Drawing Title	
Privacy Screen Detail	
Client	
Dan and Lizzie Bloxham	
Job Title and Address	
52 Parkway, Merton

CH Architectural Designer		
Issue Date	Scale @ A3	Scale @ A1
26/03/21	1:20	1:10
Drawing No	Rev	Status
006	B	Planning

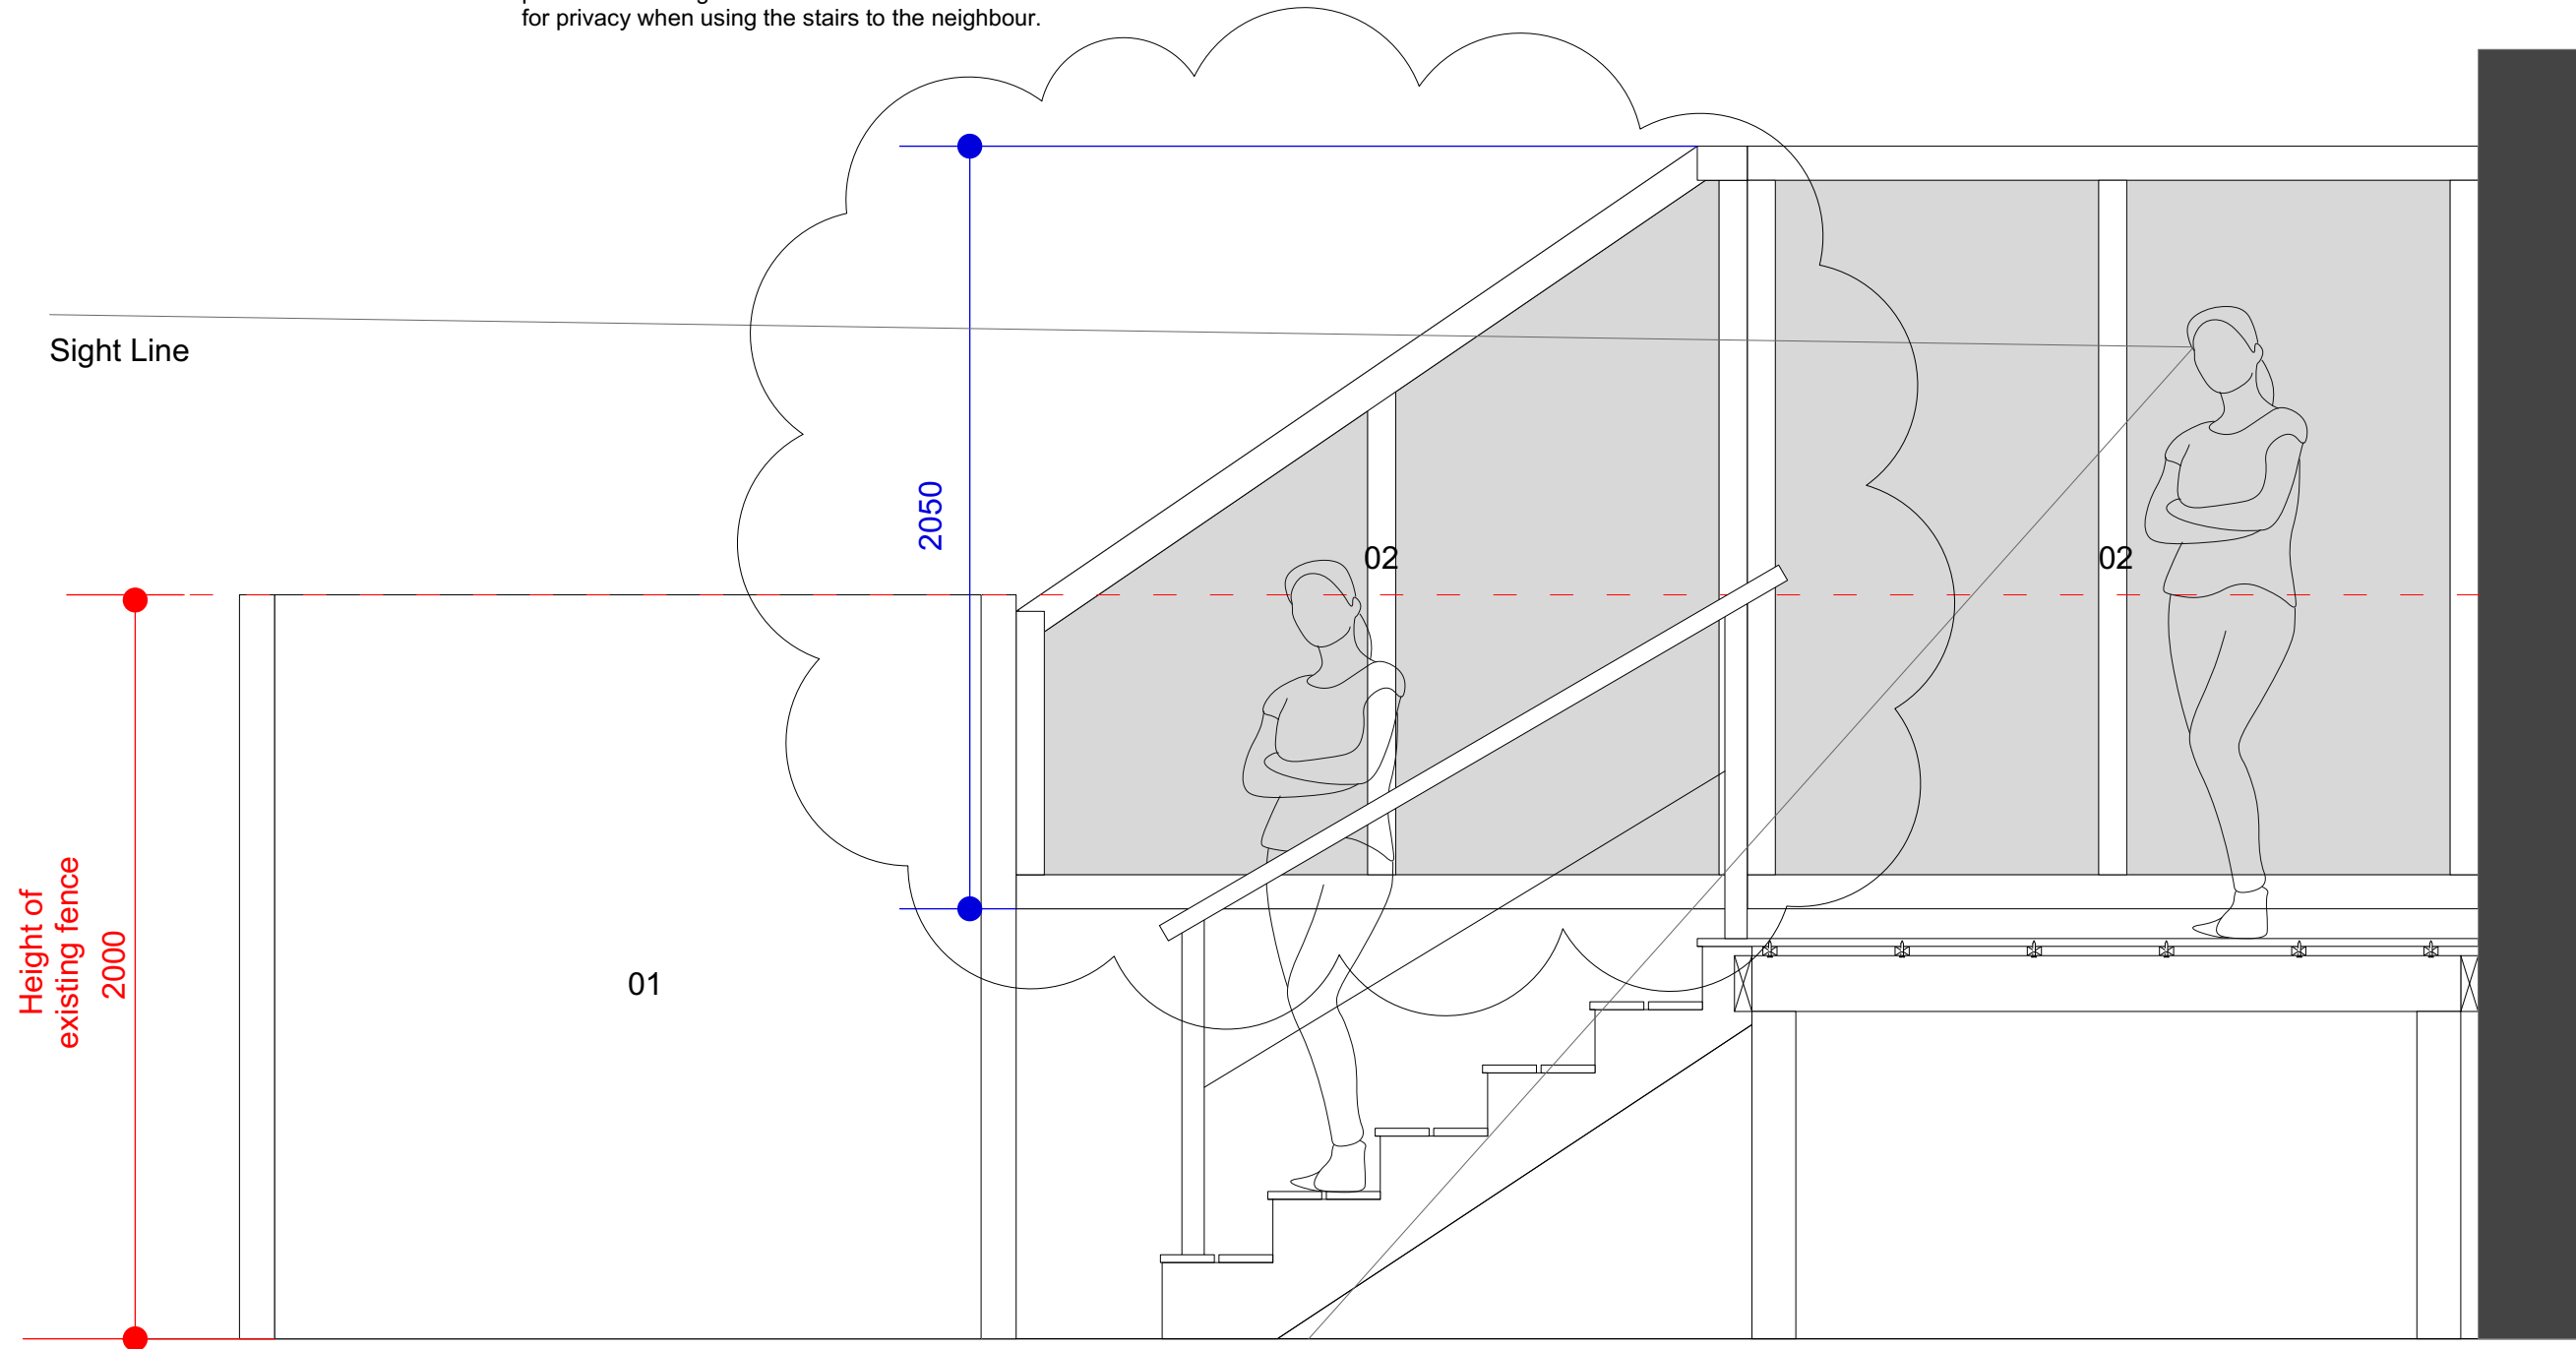
REVISION: Additional privacy screen added to address concerns of neighbouring privacy when using new stairs on the deck. This should address overlooking concerns and look visually appealing for the neighbouring property. This panel would be angled and run in parallel to the angle of the stairs. This will allow for privacy when using the stairs to the neighbour.
